AMENDMENTS TO THE DRAWINGS

App No.: 10/524,440
Inventor: Yoshiyuki Shoji et al.
Title: DEVICE FOR SUCKING LIQUID AND METHOD FOR SUCKING
LIQUID
ANNOTATED SHEET

FIG. 8

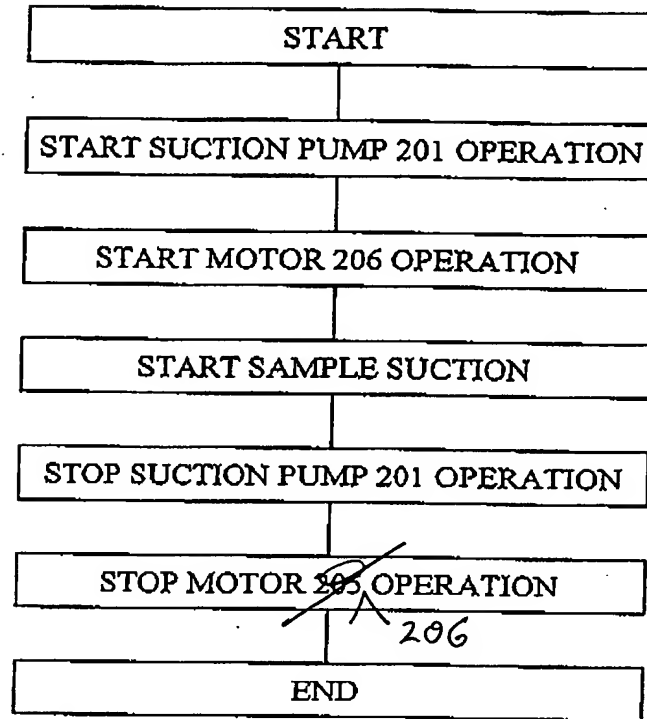
In Fig. 8, "205" has been amended to read "206" in "STOP MOTOR 206 OPERATION" in the 6th box.

FIG. 15

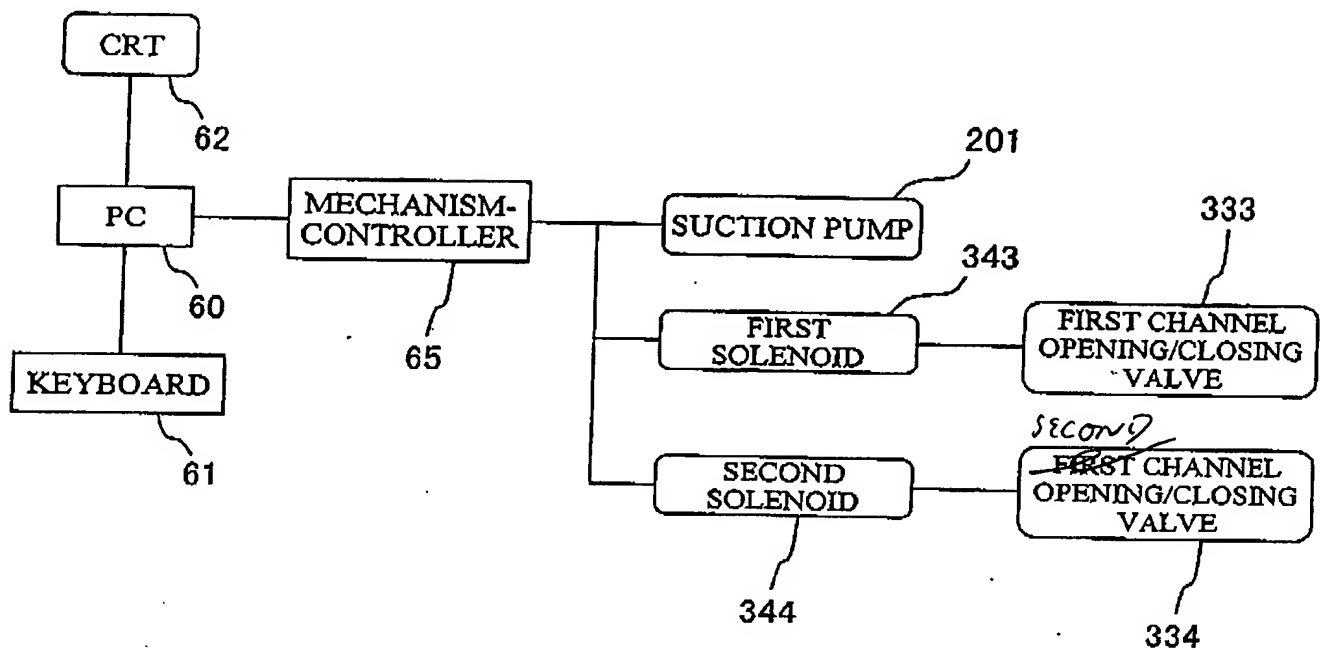
In Fig. 15, "FIRST CHANNEL OPENING/CLOSING VALVE" has been amended to read "SECOND CHANNEL OPENING/CLOSING VALVE 333" in the box 334.

FIG. 16

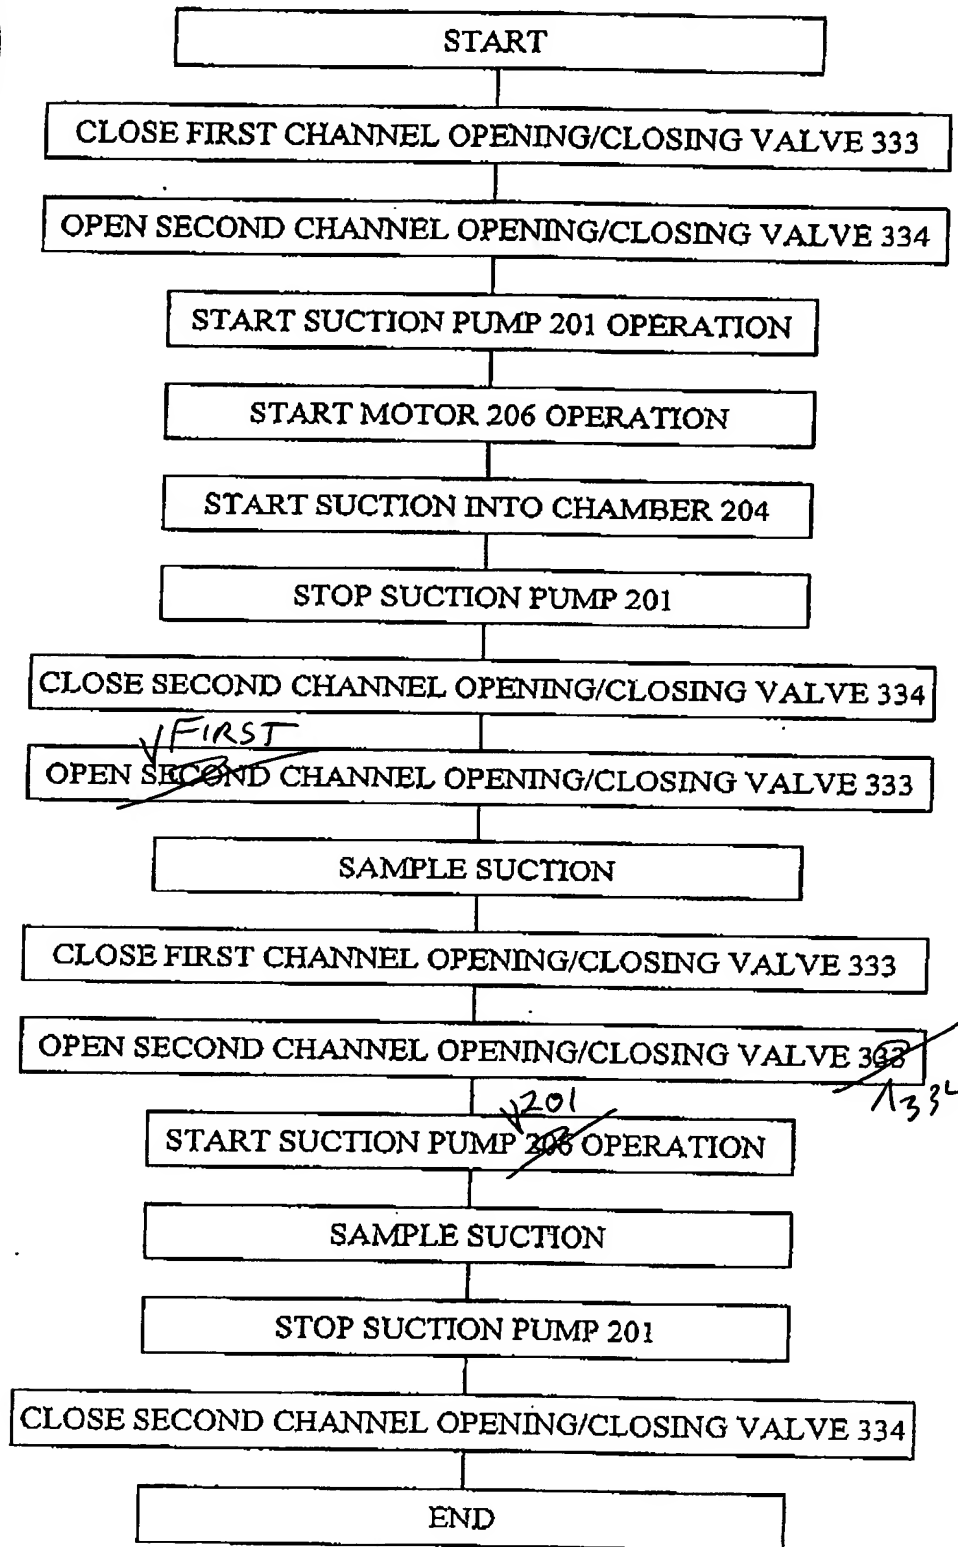
In Fig. 16, "OPEN SECOND CHANNEL" has been amended to read "OPEN FIRST CHANNEL" in the 9th box, "333" has been amended to read "334" in "OPEN SECOND CHANNEL OPENING/CLOSING VALVE 333" in the 12th box, and "206" has been amended to read "201" in "START SUCTION PUMP 206 OPERATION" in the 13th box.
